City of Dallas
2011 ADDENDUM
to the
Public Works Construction Standards - North Central Texas
As Published by the
North Central Texas Council of Governments
(Fourth Edition, October 2004)

October 1, 2011

The 2011 Addendum to the North Central Texas Council of Governments, Fourth Edition, © October, 2004, sets forth exceptions or requirements of the City of Dallas Water Utilities Department, the City of Dallas Park and Recreation Department, Trinity Watershed Management, and the City of Dallas Department of Public Works, and thereby takes precedence over any conditions or requirements of the Standard Specifications with which it may be in conflict.

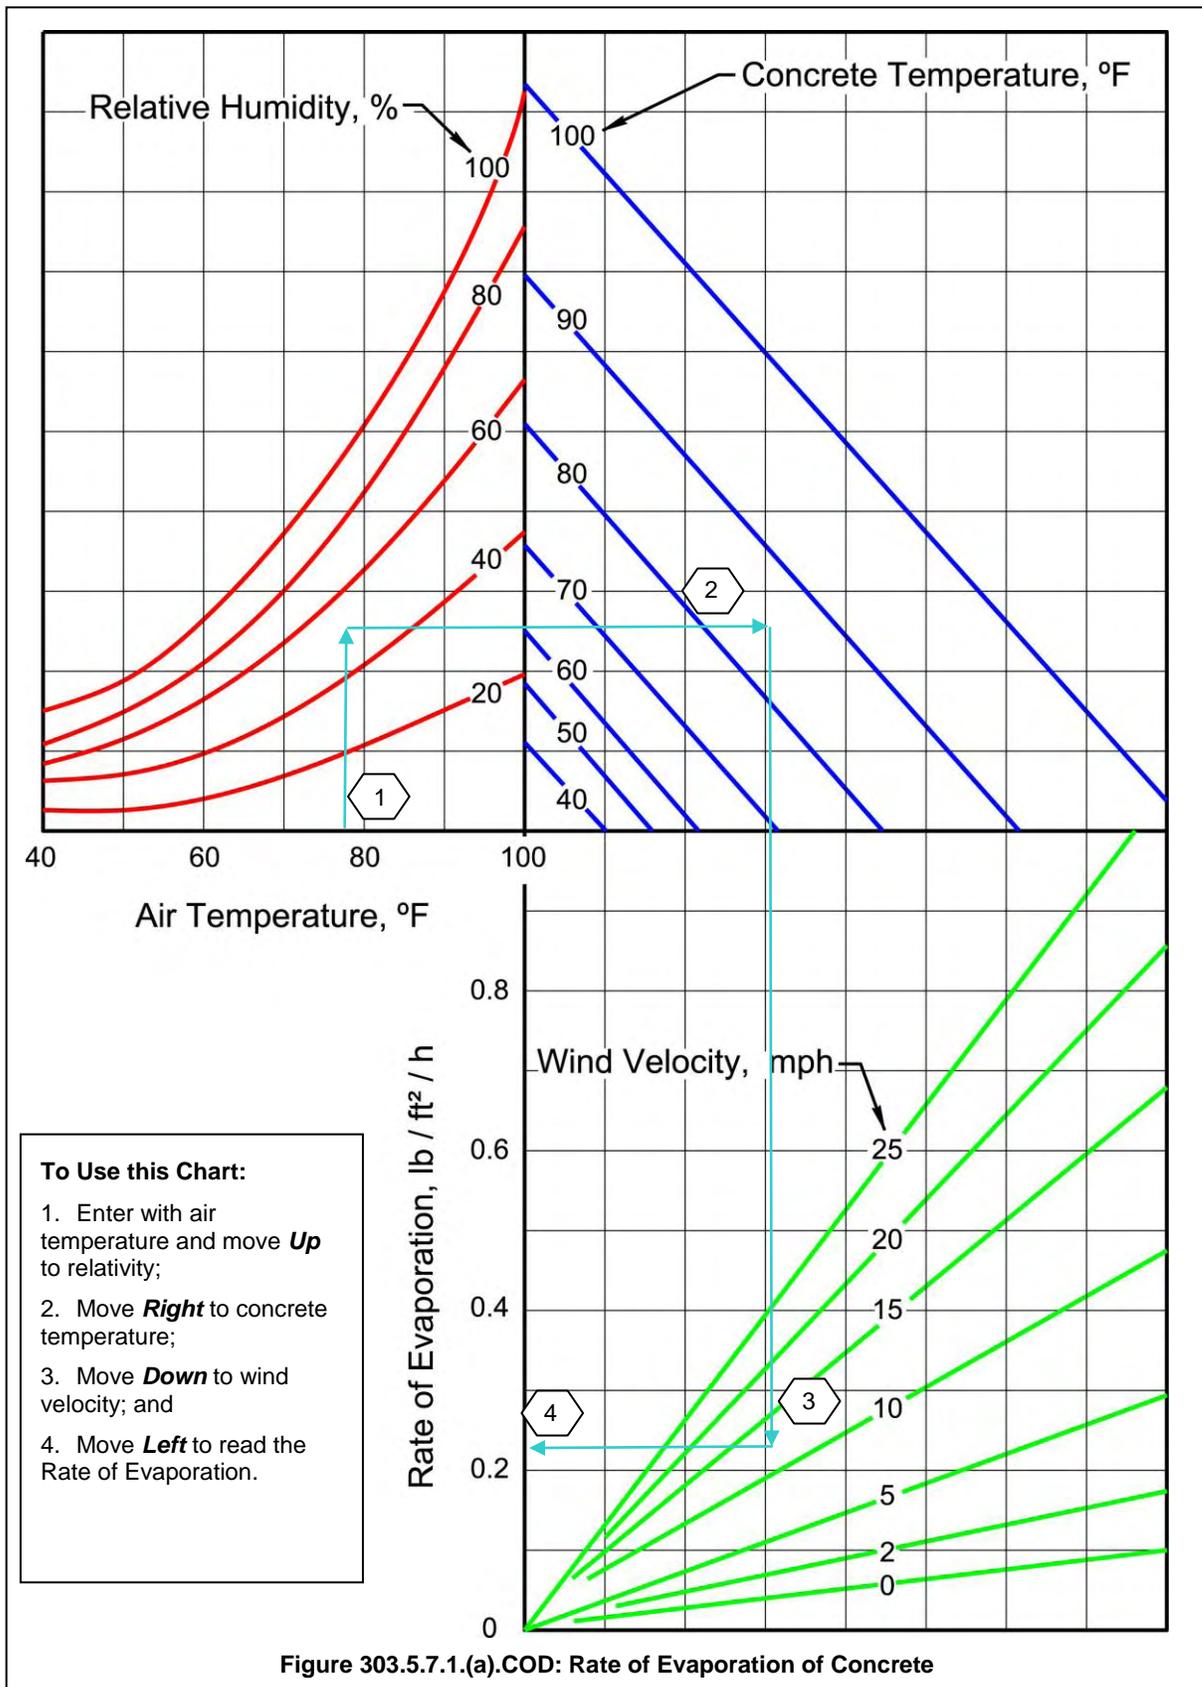
303.5.7.1.COD: PLASTIC SHRINKAGE CRACKING: When conditions of wind, humidity, ambient temperature and concrete temperature create a condition whereby surface moisture evaporation may exceed 0.2 lb. per square foot per hour as determined from the chart shown on Figure 1, a monomolecular film may be applied to the concrete or an approved polyethylene film shall be applied immediately behind the first screening. Rate of application shall be in accordance with manufacturer’s recommendations. Paving operations may also be discontinued, at the option of the CONTRACTOR, until the evaporation rate is reduced below 0.2 pound per square foot per hour. The polyethylene or monomolecular film is not a replacement for the membrane forming curing compound and their use may be discontinued once the evaporation rate has decreased to less than 0.2 lb. per square foot per hour. Application of the membrane-forming compound will be applied as specified under (I) Curing, first paragraph.
